PRELIMINARY CONSULTATION - DRAFT PLANNING PROPOSAL – LAND AT 1838 BARKERS LODGE ROAD, 1455 AND 1475 BARKERS LODGE RD, OAKDALE

ADVICE RESPONSE: Preliminary Notification - Planning Proposal - Land Adjoining Oakdale Sportsfields - 1838 Barkers Lodge Road, Oakdale (Lot 6 in DP 734561), 1475 and 1455 Burraborang Road, Oakdale (Lot 1 and Lot 2 in DP734561)

Draft Planning Proposal – Land at 1838 Barkers Lodge Road, 1455 and 1475 Burragorang Road, Oakdale (Land Adjoining Oakdale Sportsfields) (CM: 13014)

Map 1. Strategic Land and Water Capability Assessment (SLWCA) for Residential Sewered Development at 1838 Barkers Lodge Rd, and 1455 and 1475 Burraborang Road Oakdale. NB. A further farm dam occurs in the north of the site (not depicted).

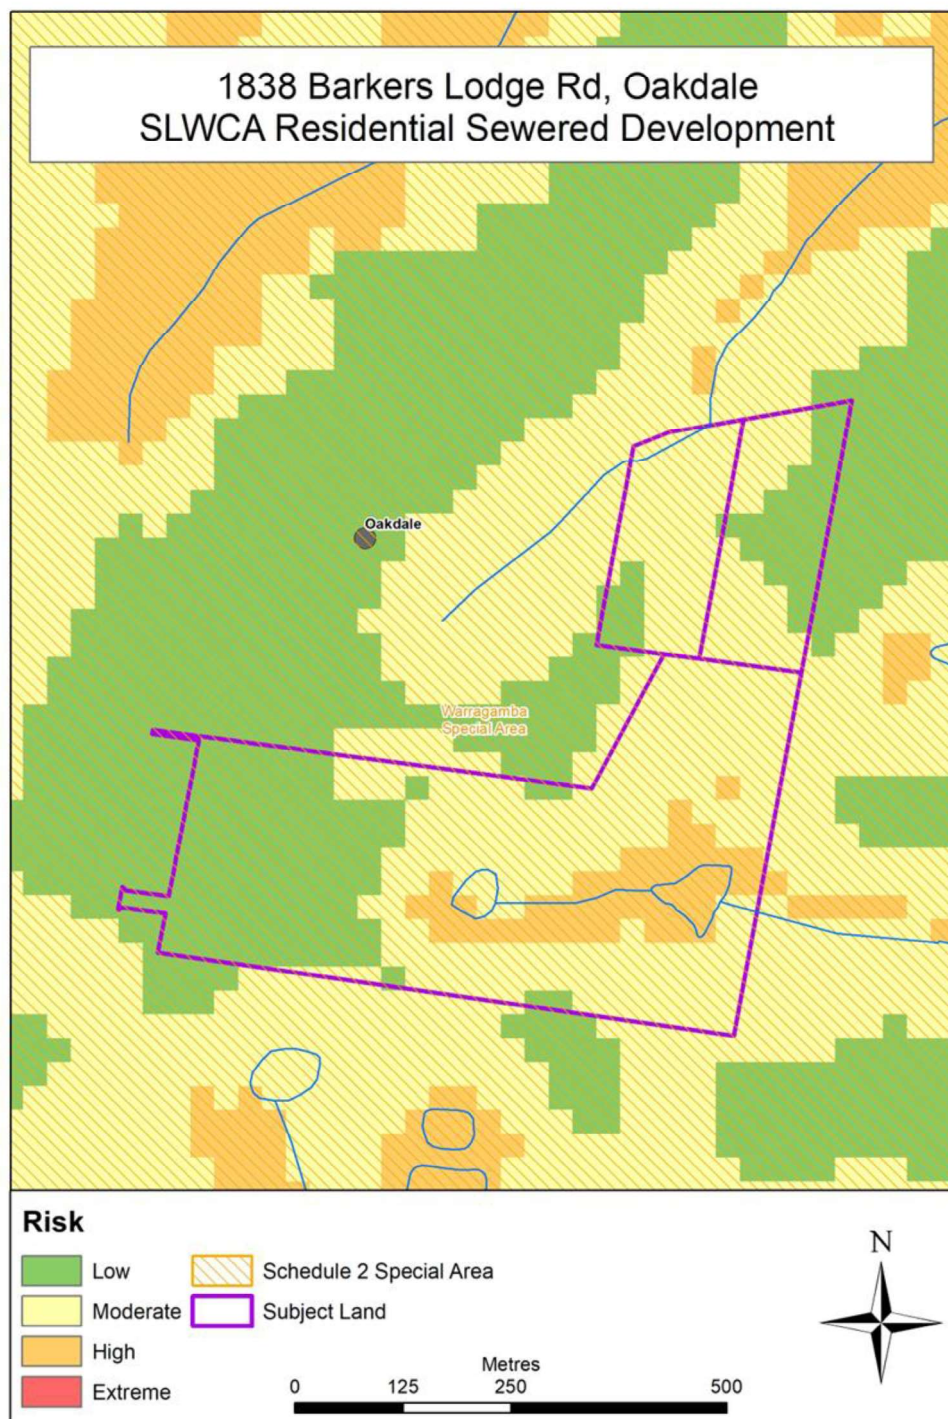
We have assumed that any land allowing the permissibility of dwellings with consent will be sewerage. The relevant SLWCA map for the site in Attachment 2 is provided on this basis. The SLWCA map shows that the water quality risks associated with the site vary from LOW to HIGH. HIGH risk areas are associated with the existing watercourse/ drainage features in the south centre of the site. Land with a HIGH risk has a LOW capability for the stated use. Areas with MODERATE and LOW risk have a MODERATE and HIGH capability for the intended use.

Figure 2 Vegetation types and proposed development footprint (Source: Scoping Proposal)

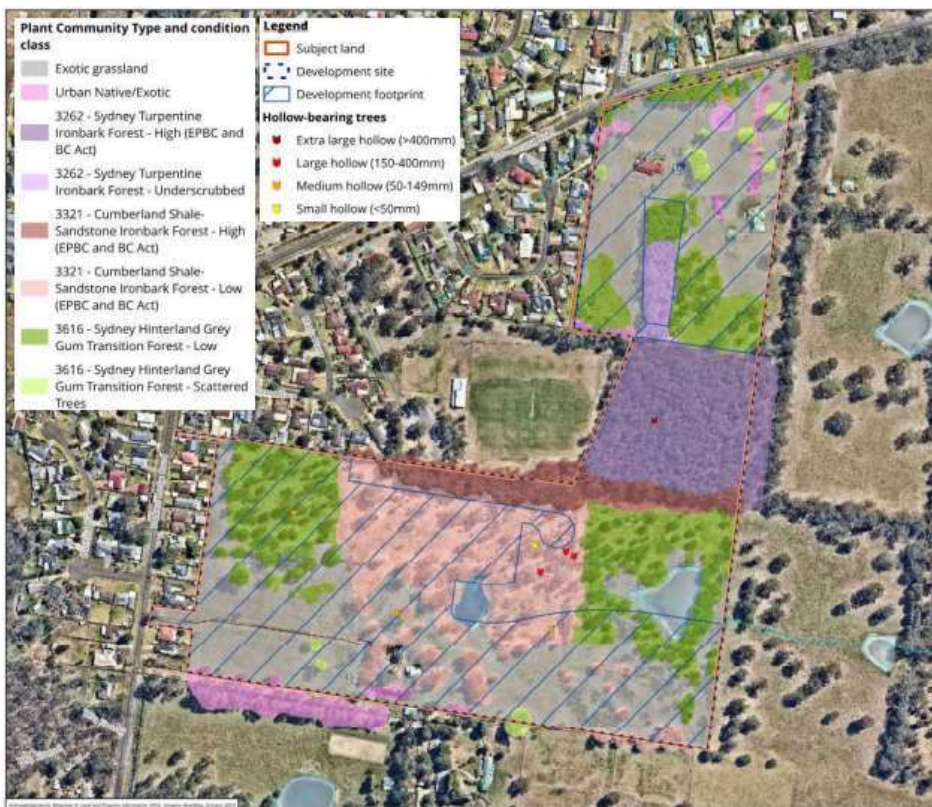
Planning Priority 13 seeks to protect biodiversity of value in different landscapes including rural zoned land. The subject site has high environmental values including Shale Sandstone Transition Forest and Cumberland Plain Woodland (see Figure 2).

The Department also notes a Biodiversity Development Assessment Report (BDAR) has now been prepared for the site, which includes key considerations, mitigation and management measures. It is calculated that a total of 227 ecosystem credits and 460 species credits would need to be retired to offset for the anticipated clearing of the proposed development areas and thinning of vegetation within areas proposed to be zoned C3 Environmental Management.

Consultation with Department of Climate Change, Energy, the Environment and Water is required to confirm they do not object to the proposal.

Figure 3 Bushfire Prone Land within and surrounding the site
(Source: NSW Planning Portal Spatial Viewer)

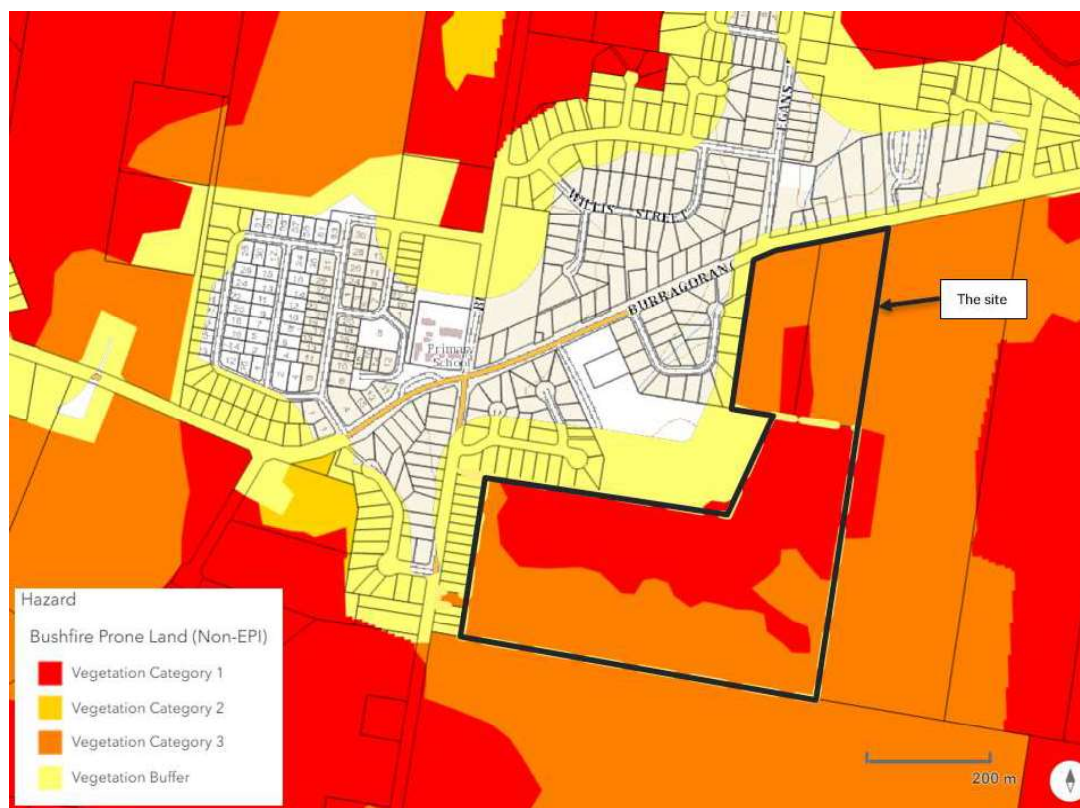
Figure 3 shows the extend of bushfire prone land within and surrounding the subject site. The subject site is mapped and containing areas of Vegetation Category 1, Vegetation Category 3 and Vegetation Buffer. As such, any future development within the subject site will need to consider requirements under Planning for Bushfire Protection 2019.

The proposal indicates a strategic bushfire study has been prepared in accordance with the requirements of the Planning for Bushfire Protection 2019. It is noted that the study concludes that the proposal can respond to the bushfire risk affecting the site and which will satisfy the aim, objectives and requirements within PBP to provide for the protection of life and the minimisation of impact on property while having due regard to the development potential, site characteristics and protection of the environment and identify the required APZs and demonstrate consistency with the relevant provisions.

Consultation with the NSW Rural Fire Service is also required that they do not object to the proposal.
